MILO RESIDENCE
11901 SW 63 RD AVE
PINECREST, FL 33156

P1.2

SCOPE OF WORK FOR REVISION A :
OWNER DESIGN CHANGE REMOVING
DOUBLE HEIGHT LIVING ROOM. ALL
ARCHITECTURAL SHEETS AFFECTED,
SOME MEP PAGES AND SOME STRUCTURAL.
SEE A.D.O. REV 3 COLUMN FOR UPDATED
SHEET LIST.

NORTH
SECOND FLOOR WATER PLAN
SCALE: 3/16" = 1'-0"

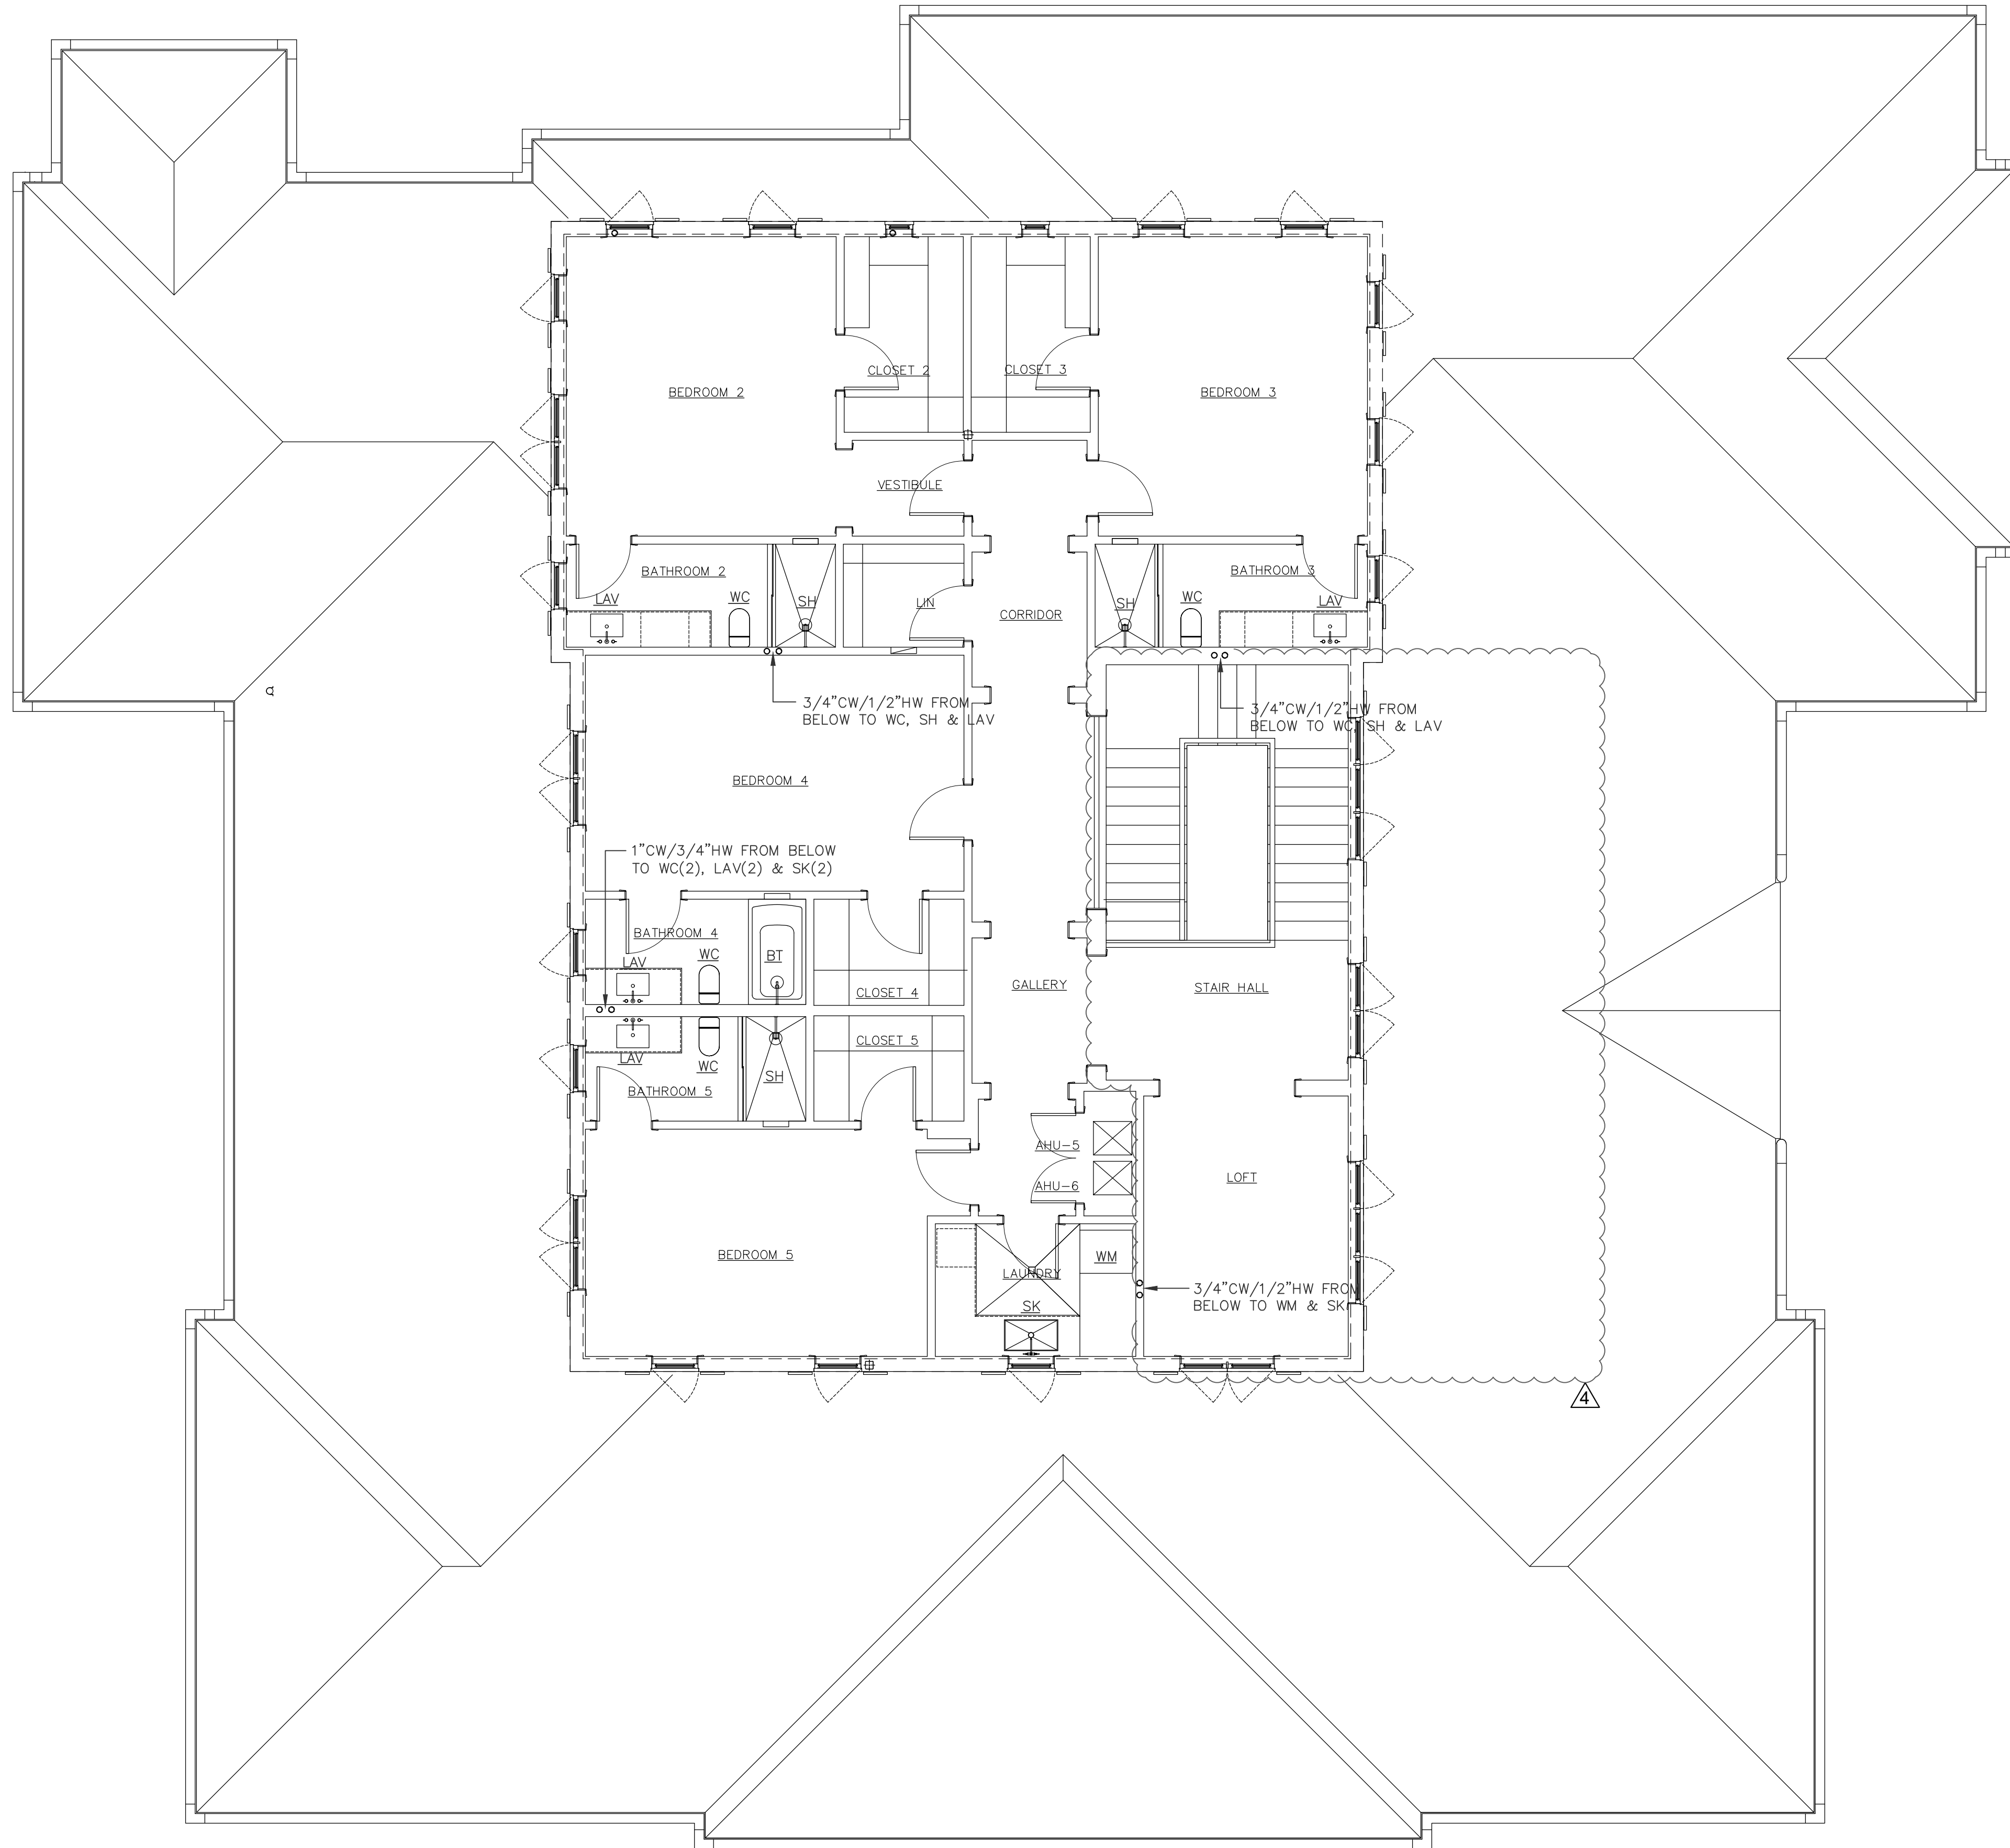
SCOPE OF WORK FOR REVISION A:
OWNER DESIGN CHANGE REMOVING DOUBLE HEIGHT LIVING ROOM. ALL ARCHITECTURAL SHEETS AFFECTED, SOME MEP PAGES AND SOME STRUCTURAL. SEE A.O.D REV 3 COLUMN FOR UPDATED SHEET LIST.
